# ENVIRONMENTAL REVIEW TEAM REPORT

## BEAVER BROOK FLOOD CONTROL PROJECT MILFORD, CT

**BEAVER BROOK FLOOD  
CONTROL PROJECT  
MILFORD, CT  
SEPTEMBER 1984**

# FIGURE 4 CONCEPTUAL PROJECT DESIGN

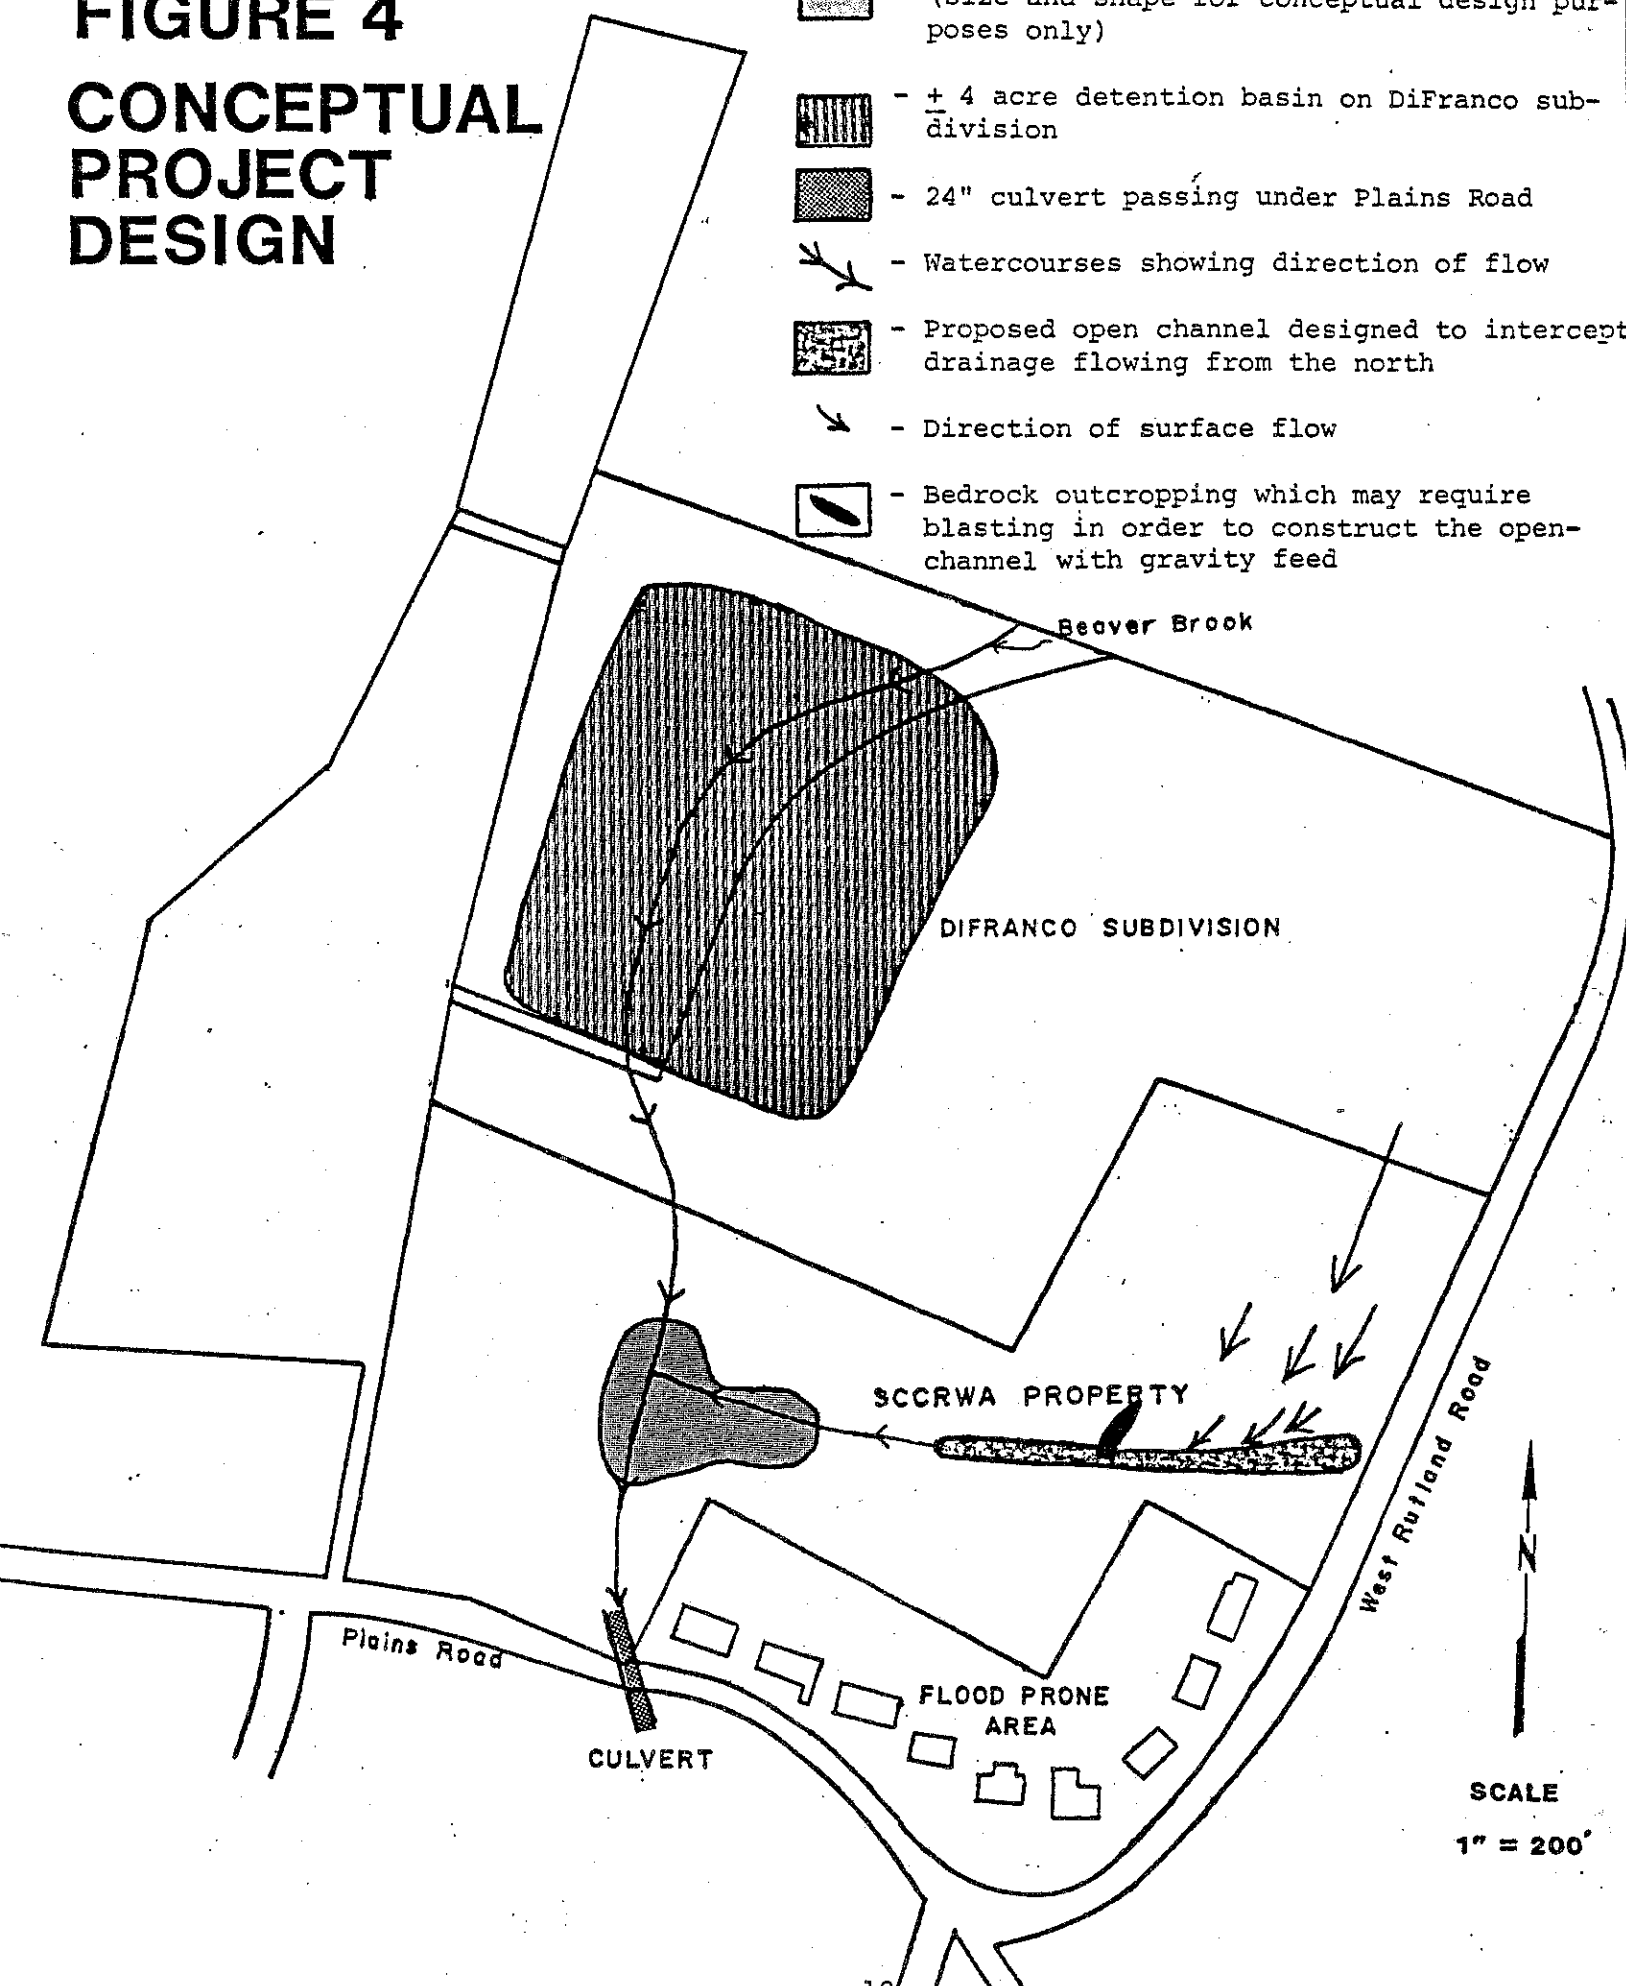
If the project is implemented, several test holes should be excavated in the area of the proposed detention basin to determine if an adequate depth for the pond can be accomplished. According to the present plans, the proposed project (detention basin) would also include the construction of an open channel which would extend from the east side of the detention basin (see Figure 4). The purpose of this channel would be to intercept surface runoff flowing from the area northeast of the flood-prone area. It would ultimately discharge the collected water into the detention basin.

A ridge of bedrock outcrop appears to run in a north-east-southwest direction in the area between the proposed detention basin and West Rutland Road. Due to the presence of bedrock, it may be necessary to blast the rocks in order to construct the channel so that water can flow by gravity to the detention basin.

Based on City topographic mapping, the elevation change between where Beaver Brook enters the subject property and the intake culvert to the storm sewer on Plains Road is less than two feet. This severely limits the flood storage available on the existing site. Any detention structure would have to be designed to store floodwaters below elevation 98 in order to not flood adjacent properties. In order to store flood waters to elevation 98, it would be necessary to construct an embankment parallel to Plains Road, tying into elevation 98 to the west and running north along the first residential lot, again tying into elevation 98. Under this scenario, less than five acre-feet of storage could be provided. For comparison, the detention basin immediately upstream presently under construction as part of the DiFranco subdivision will provide 15.60 acre-feet of storage.

The available flood storage at the site is further controlled by the invert elevations and capacities of the piping system into and within Plains Road. Flood storage can only be considered above the normal outlet elevation and therefore excavating the site to obtain additional storage area would entail lowering the elevations of the outlet into Plains Road. It could be feasible to excavate the area and create a permanent water body for recreation, wildlife, aesthetics, etc. The construction of any such detention structure would also require the construction of a defined channel and/or berm along the northern edge of the residential lots to contain runoff from the northeast.

In summary, there appears to be three basic alternatives available for construction of a detention basin in the subject area. One alternative would be to excavate the area and lower the invert elevation of the culvert under Plains Road. This alternative would offer the most storage capacity. A second alternative would be to construct an embankment detention basin to approximate elevation 98 on the site as previously discussed. This alternative would provide very limited storage capacity, but would be effective in mitigating flood damage from some of the smaller storm events. The third alternative would entail excavating the area, but leaving the culvert under Plains Road at its current elevation. This would likely provide a storage capacity somewhere between the other two alternatives, depending upon the water level maintained in the basin. Should alternative one or three be chosen, it would be desirable to monitor the ground water levels in the area via an observation well or wells on the site. It would also be desirable to observe water flows through Beaver Brook during the wet time of the year. Consideration should also be given to installing and maintaining a sediment trap if either alternative one or three is chosen. This will help maintain the permeability of the bottom of the basin. Construction of the diversion channel from West Rutland Road to the detention basin would be desirable under any of the three alternatives.
